3980 WALKER ROAD
 SITE PLAN DOCUMENTS
 EL PASO COUNTY, COLORADO

SITE PLAN KEYMAP

V3_Site Development Plan with Contours.pdf Markup Summary

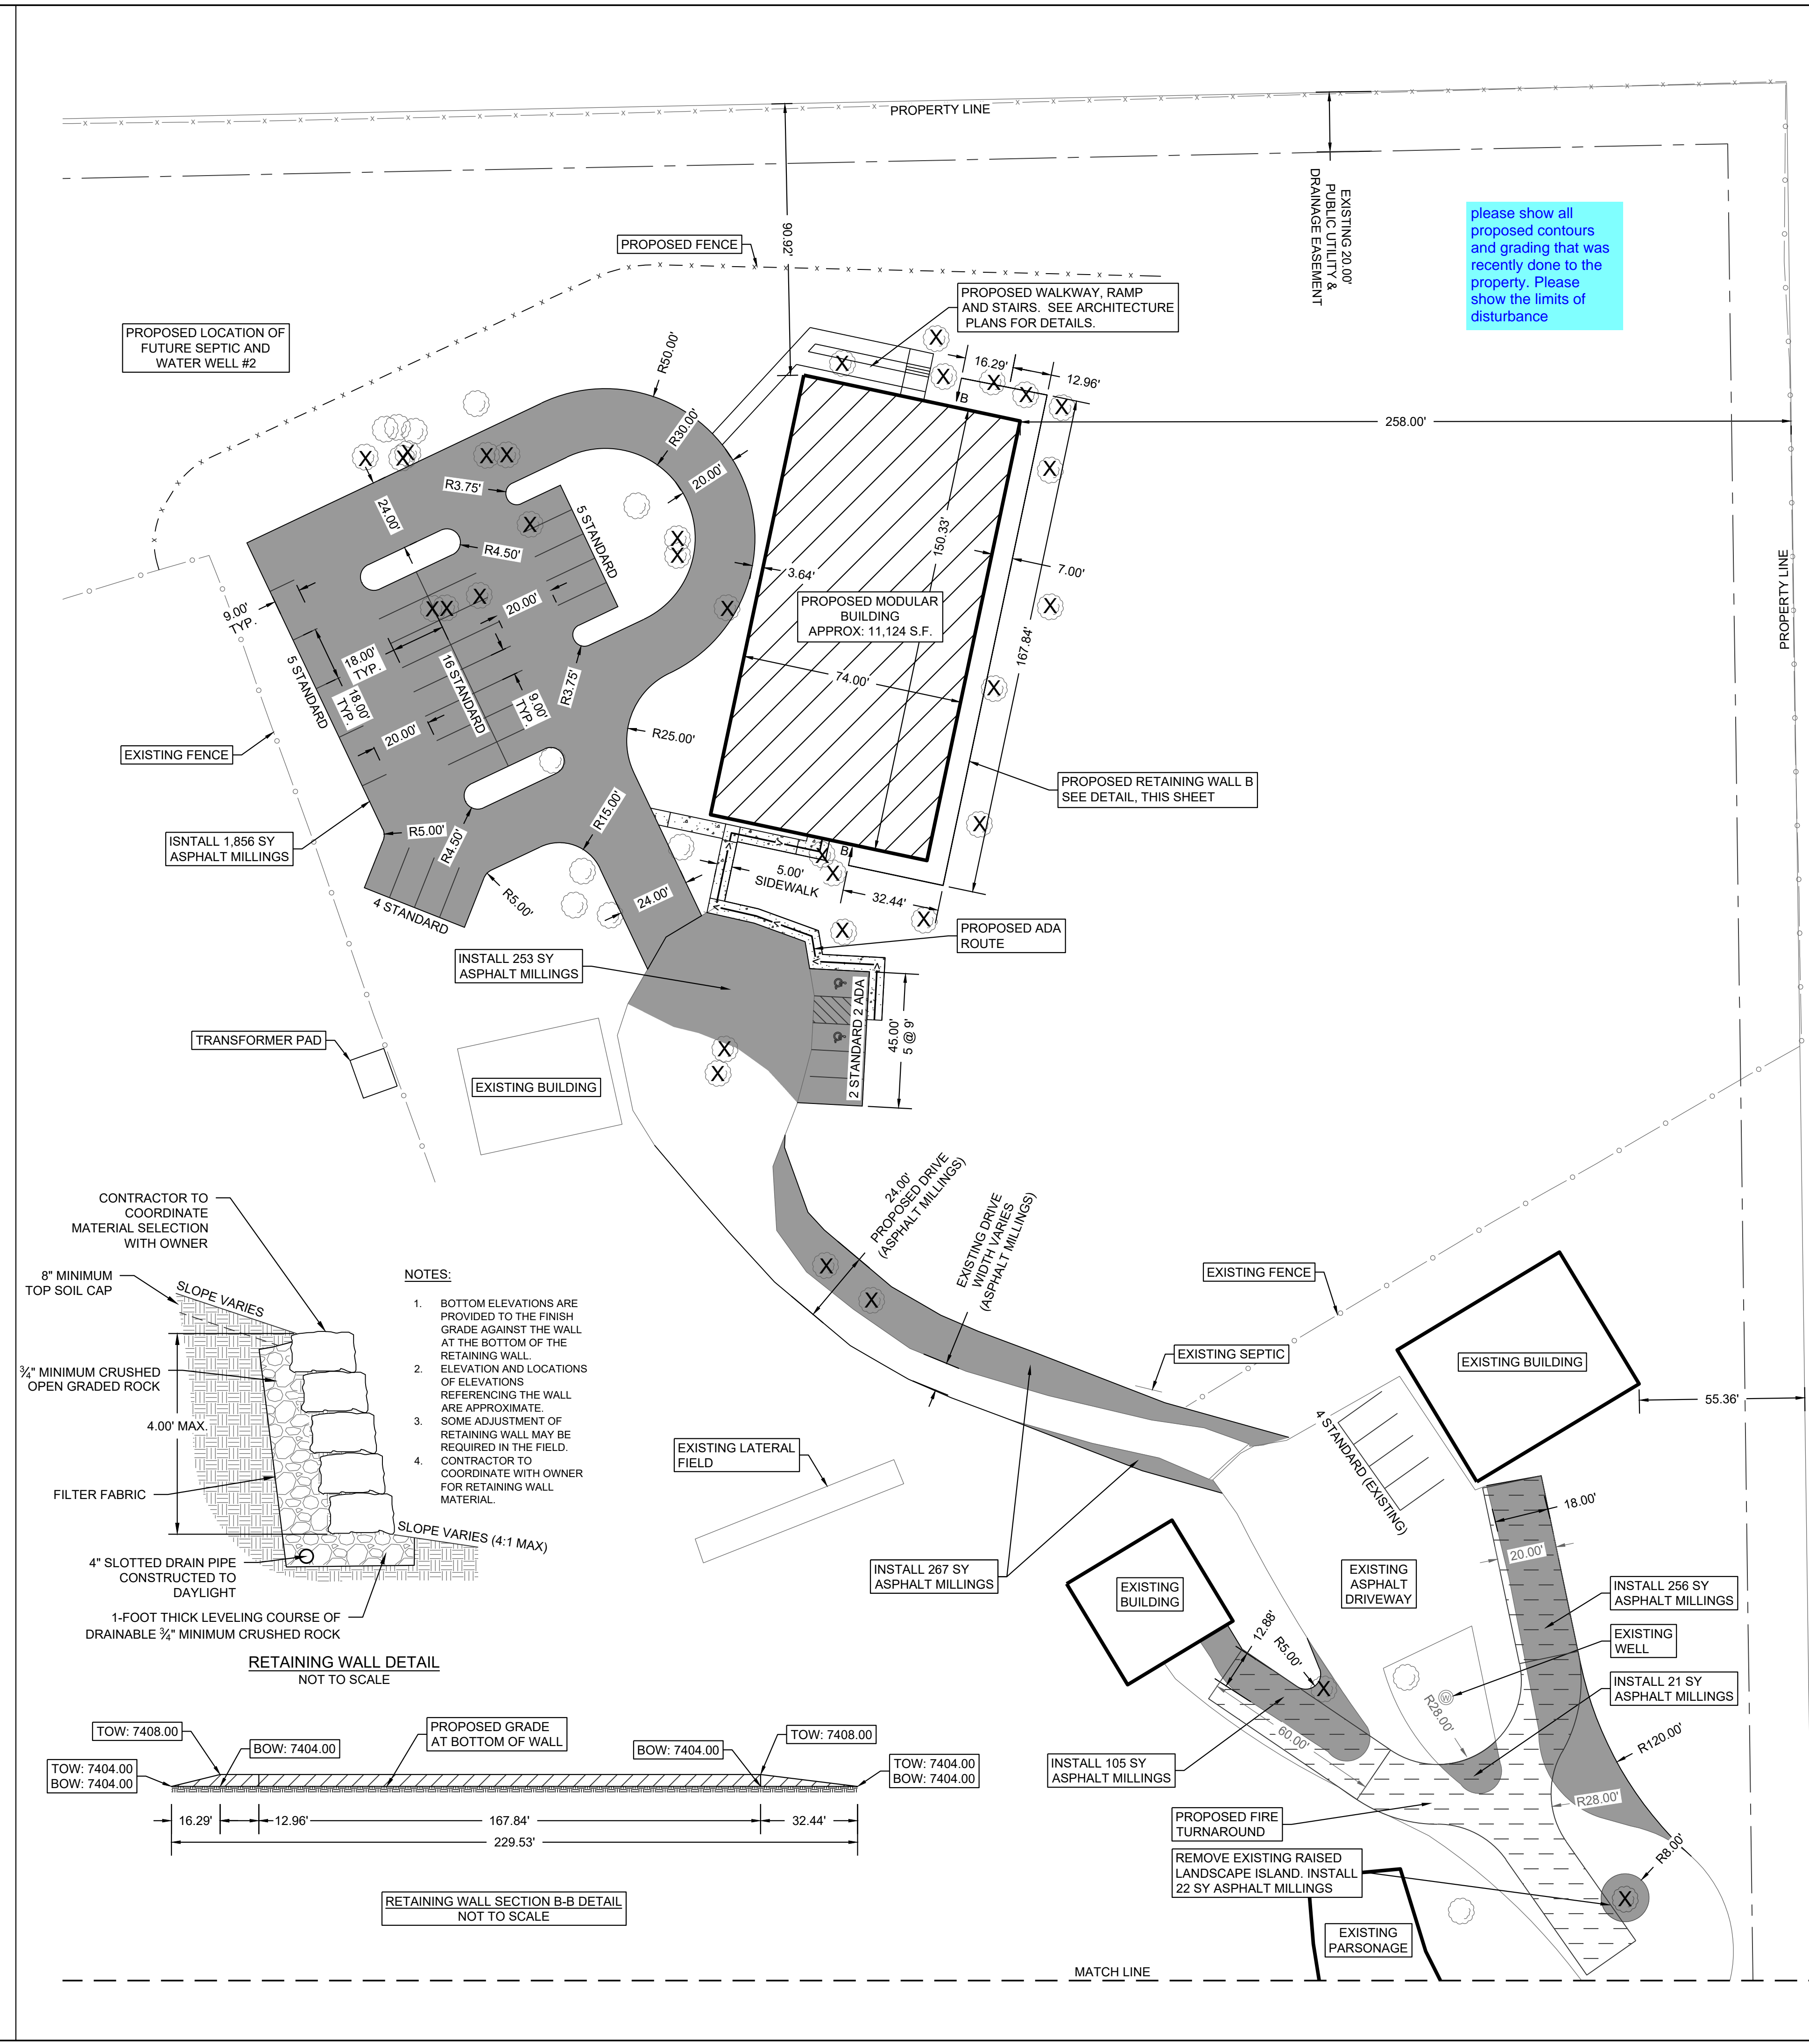
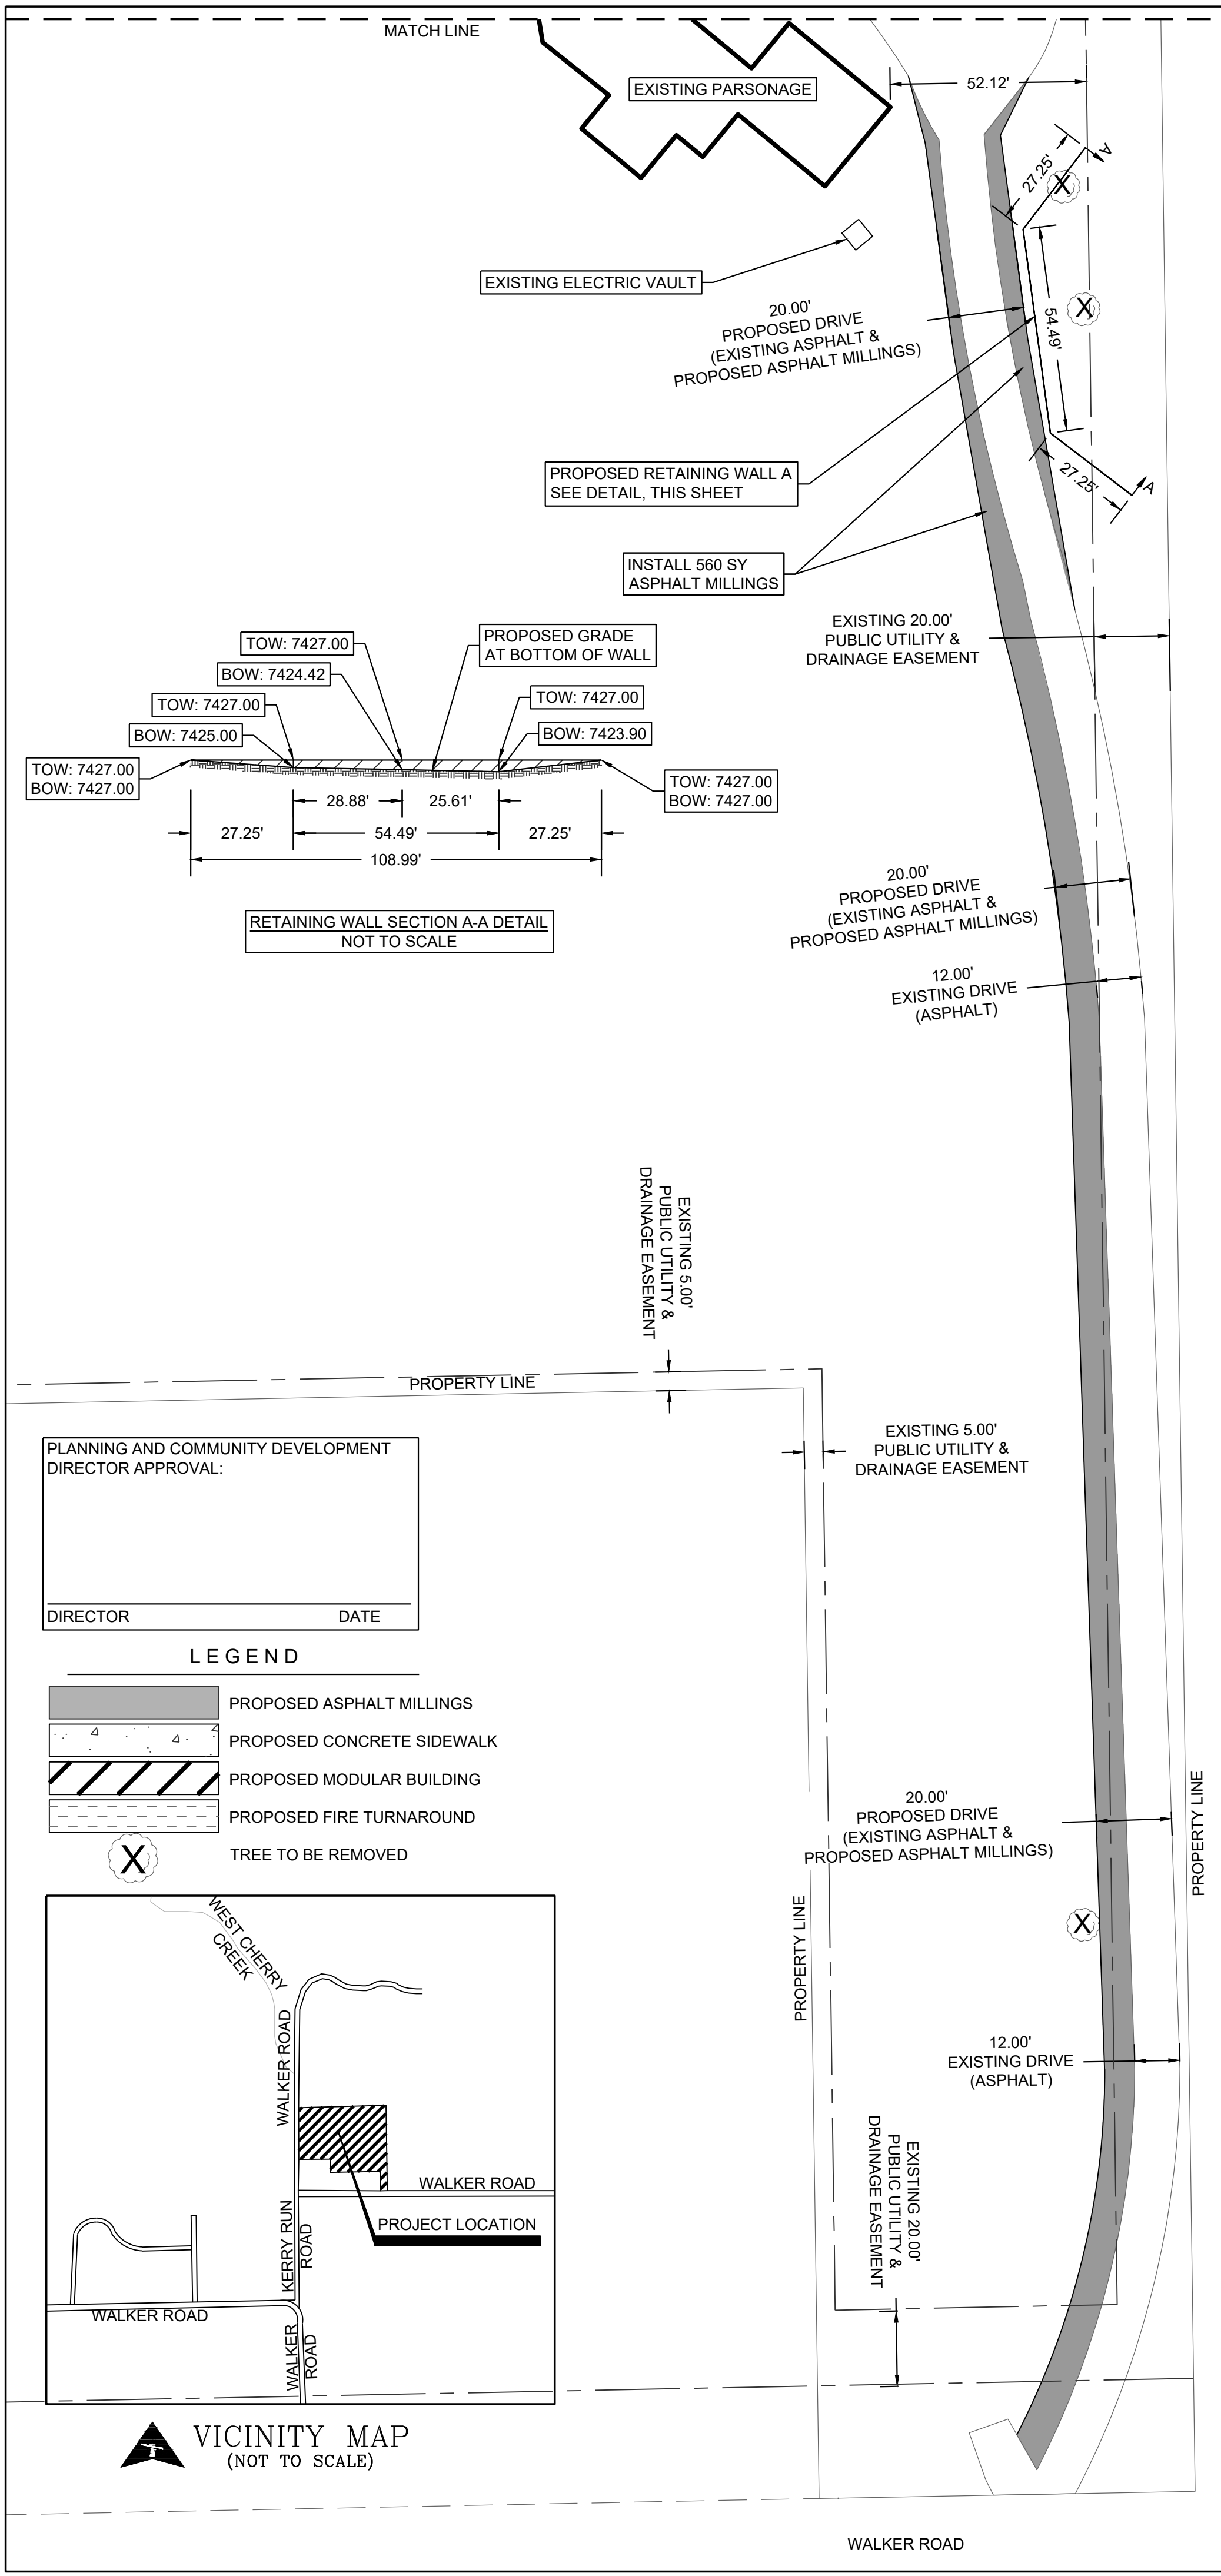
please show all proposed contours and grading that was recently done to the property. Please show the limits of disturbance
